## Abstract

## Improved Power board version 03 (with temperature monitoring)

## Special doubler capacitors for intensive flashing

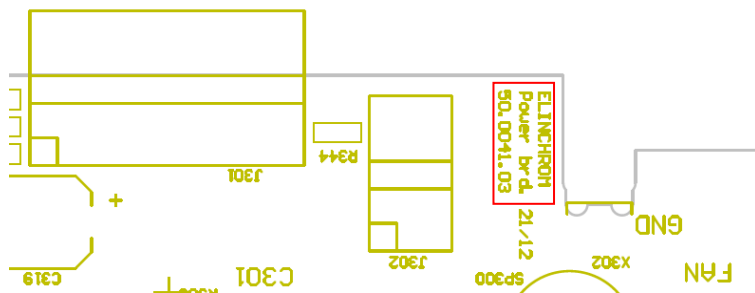
To prevent the overheating of the doubler capacitors, we have been adding the monitoring of the temperature on one doubler (Power Control board version 03, 50.0041.03).

We now we are able extend the life time of the doublers by introducing **a new type of polarized capacitor** that are better suited for frequently charging / discharging. These new capacitors will be introduced in the series as soon as possible.

If you have to repair a board with one of the damaged doubler capacitor (bumped or electrolyte leakage), you can order now the new code No. 104.209 (220 $\mu$ F – 400VDC, 105°C, size 25.4 x 35 mm).

We recommend to replace all the 4 capacitors at locations C301, C302, C303, C304. Mostly C301 or C302 are failing (C303 & C304 are used only for 115V – 60Hz mains).
